Item Name: Fwd Crosstube - High 407

DART AEROSPACE LTD		Work Order:	131480
Description: Crosstube High Fwd (407)		Part Number:	D407-667-105
Inspection Dwg: D407-667-145 Rev: C		Page 1 of 1

DRAWING NO. D407-667-145	TITLE CROSSTUBE ASS'Y (407 HIGH FWD)	REV. C	DART AEROSPACE LTD ENGINEERING ORDER		D.E.O. NO. D407-667-145-C-1	SHEET NO. SHEET 1 OF 1	SCALE NTS
DRAWN P	CHECKED ASS	MFG. APPR. B	APPROVED WD		DE APPR. H		
DATE 11.07.15	DATE 11.07.22	DATE 11.07.22	DATE 11/07/22		DATE 11.07.21

DRAWING NO. D407-667-145	TITLE CROSSTUBE ASS'Y (407 HIGH FWD)	REV. C	DART AEROSPACE LTD ENGINEERING ORDER	D.E.O. NO. D407-667-145-C-2	SHEET NO. SHEET 1 OF 1	SCALE NTS
DRAWN AJS	CHECKED [Signature]	MFG. APPR. [Signature]	APPROVED [Signature]	DE APPR. [Signature]		
DATE 12.08.02	DATE 12.08.02	DATE 12.08.02	DATE 12.08.02	DATE 12.08.02	DATE 12.08.02

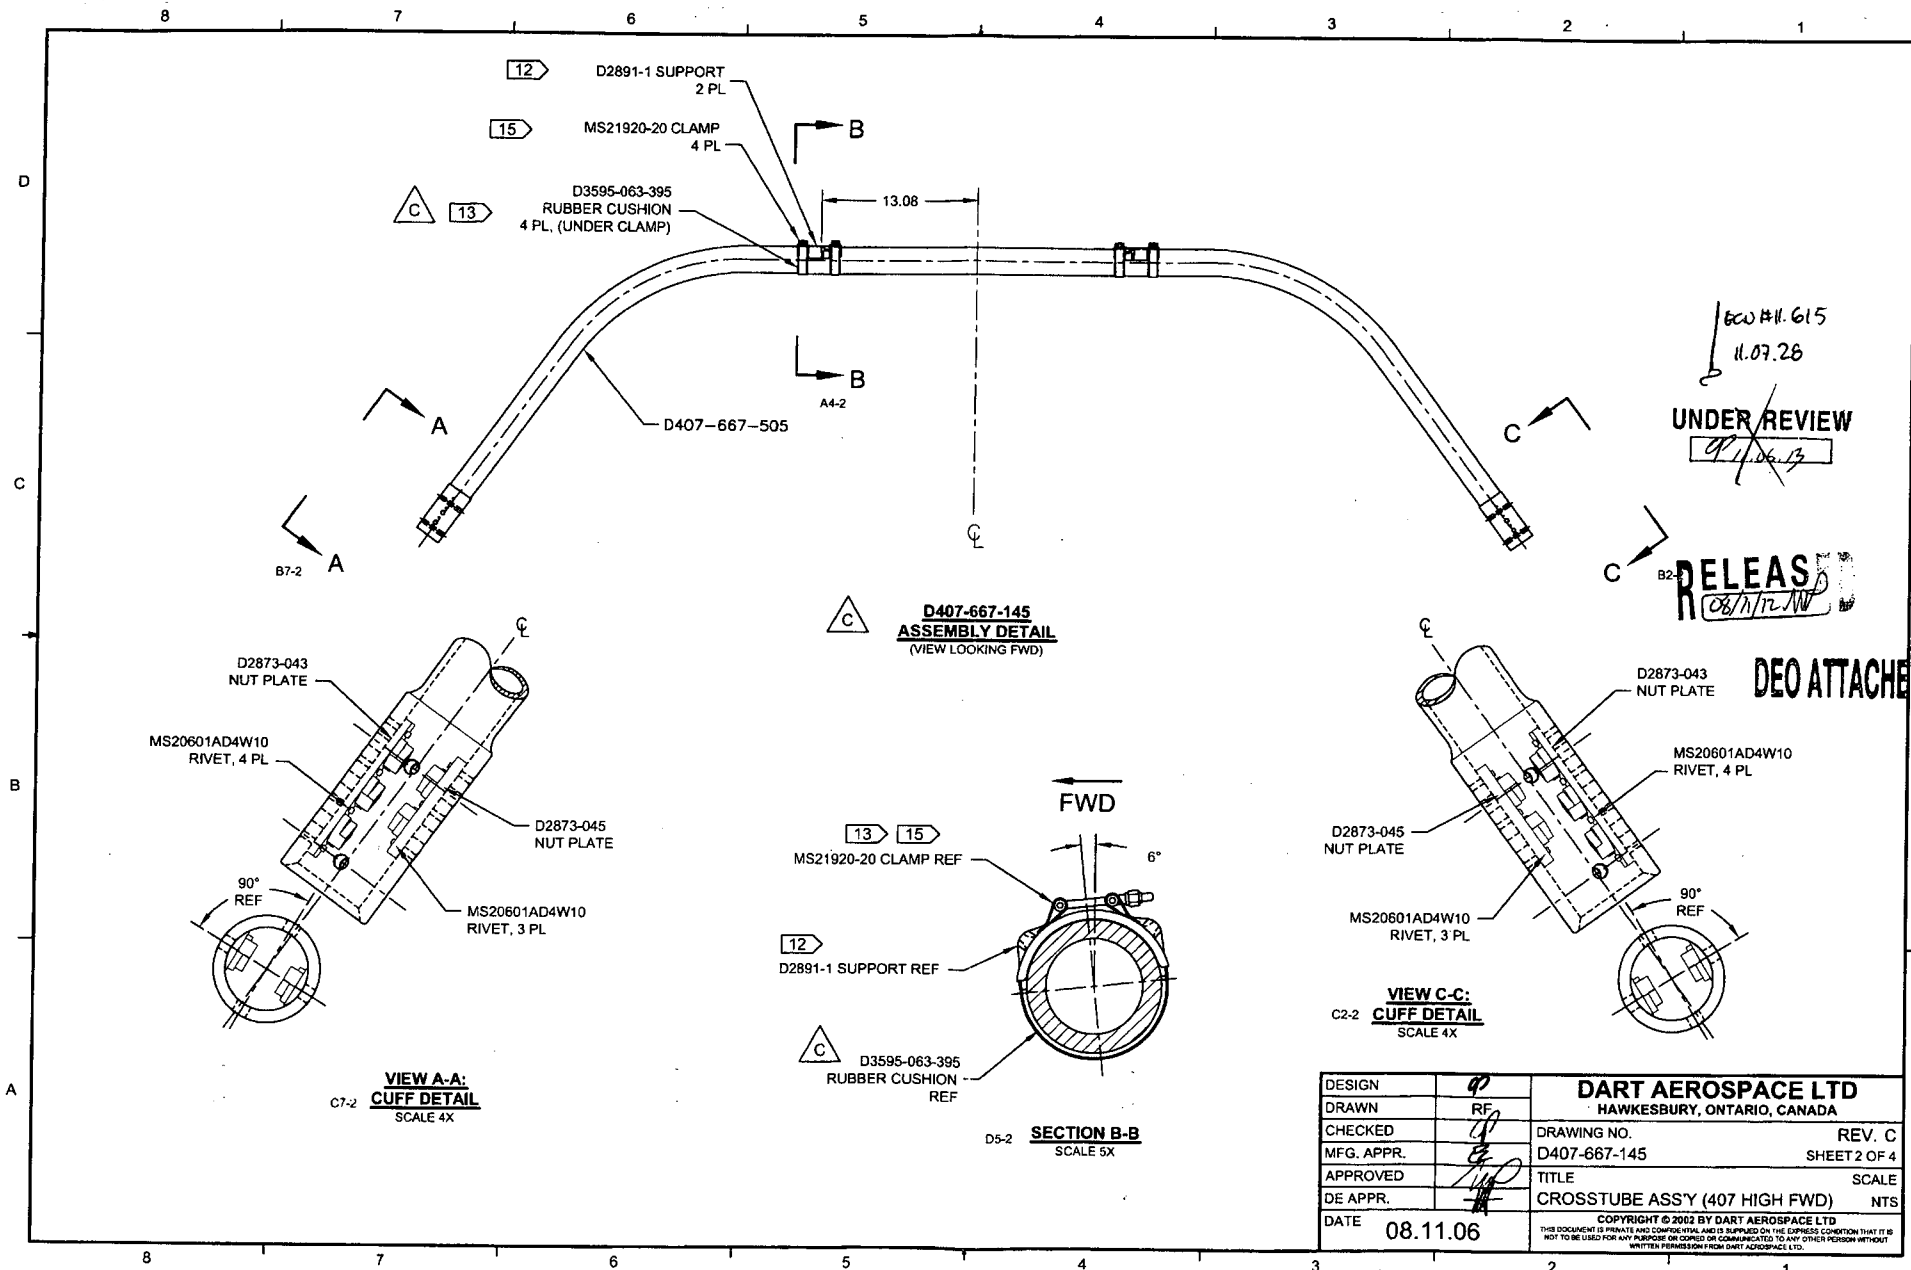
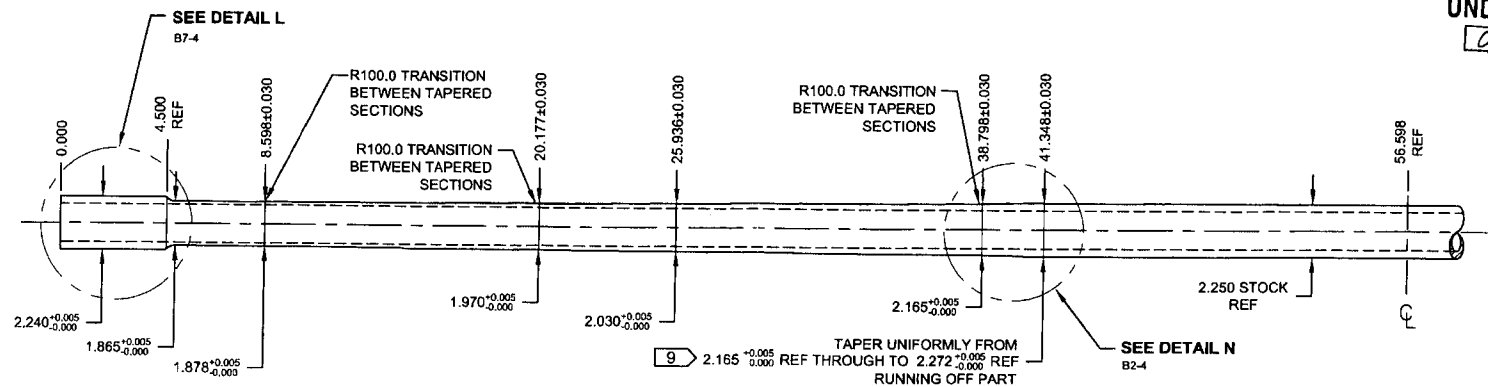
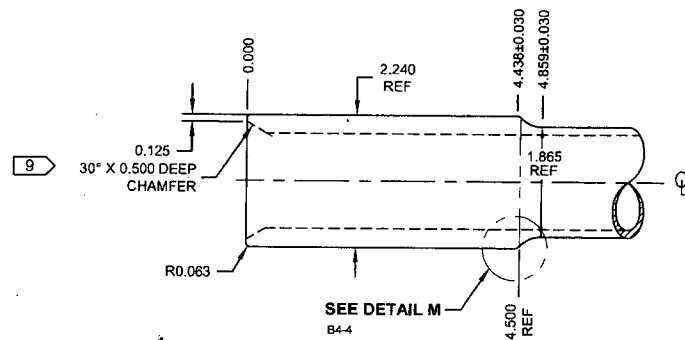
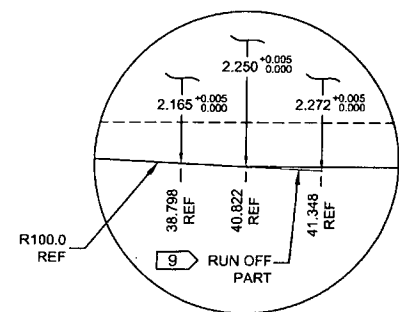
REPLACE MAGNOBOND WITH PROSEAL.

Item	Qty -145	Part Number	Description
9	A/R	PROSEAL 890 B-2	SEALANT, AMS-S-8802 CLASS B-2

9	A/R	MAGNOBOND 6398	ROCKWELL SPECIFICATION RBO-120-023 ADHESIVE (TEXTRON/BELL SPEC. 299-947-100, TYPE II, CLASS 2 ADHESIVE)
---	-----	----------------	---

NOTE 12 & 15, SHEET 1 IS AMENDED AS FOLLOWS:

- 12) INSTALL D2891-1 SUPPORT USING 0.03" TO 0.06" THICK LAYER OF MAGNOBOND 6398 PER QSI 015. LET CURE FOR 12 HOURS AFTER INSTALLATION AND PRIOR TO PACKAGING.
- 15) TORQUE CLAMPS 80 TO 100 IN-LB. ENSURE AT LEAST 1.5 THREADS SHOWING IN SAFETY AND THAT NUT HAS NOT BOTTOMED-OUT AFTER TORQUING.

- 12) TO INSTALL D2891-1 SUPPORT: ABRASE MATING SURFACE OF SUPPORT AND CROSSTUBE WITH 180-GRIT SANDPAPER AND REMOVE RESIDUE WITH MEK (OR EQUIVALENT). APPLY A 0.04" TO 0.07" THICK LAYER OF PROSEAL 890 CLASS B-2 (OR AMS-S-8802 CLASS B-2) SEALANT TO MATING SURFACE OF SUPPORT.
- 15) TORQUE CLAMPS 80 TO 100 IN-LB. ENSURE AT LEAST 1.5 THREADS SHOWING IN SAFETY AND THAT NUT HAS NOT BOTTOMED-OUT AFTER TORQUING. **PRIOR TO PACKAGING, RE-CHECK TORQUE ON CLAMPS AFTER PROSEAL 890 SEALANT HAS CURED FOR 72 HOURS.**

DETAIL P
BONDING STRAP INSTALLATION 2 PL

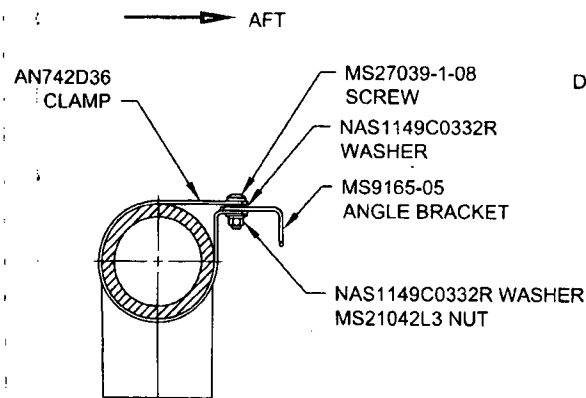
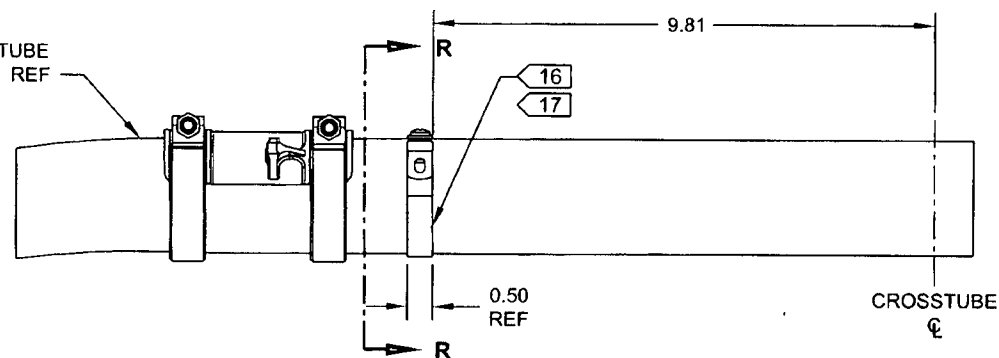
ADD ELECTRICAL GROUNDING STRAP

ITEM	QTY -145	PART NUMBER	DESCRIPTION	
1	X	D407-667-145	CROSSTUBE ASSEMBLY (407 HIGH FWD)	
10	2	AN742D36	CLAMP	} ADD
11	2	MS9165-05	ANGLE BRACKET	
12	2	MS21042L3	NUT (OR MS21042-3)	
13	2	MS27039-1-08	SCREW	
14	4	NAS1149C0332R	WASHER (OR AN960C10L)

- 16) MASK AREA UNDER CLAMP PRIOR TO PAINTING
 - 17) SEAL EDGES WHERE AN742D36 CLAMP MEETS WITH THE CROSSTUBE USING SIKAFLEX-241/-291 OR MIL-S-8802 CLASS B2 OR PROSEAL 890 SEALANT
 - 18) PERFORM RESISTANCE CHECK TO ENSURE MAX RESISTANCE IS 10 MILLIOHMS
- } ADD
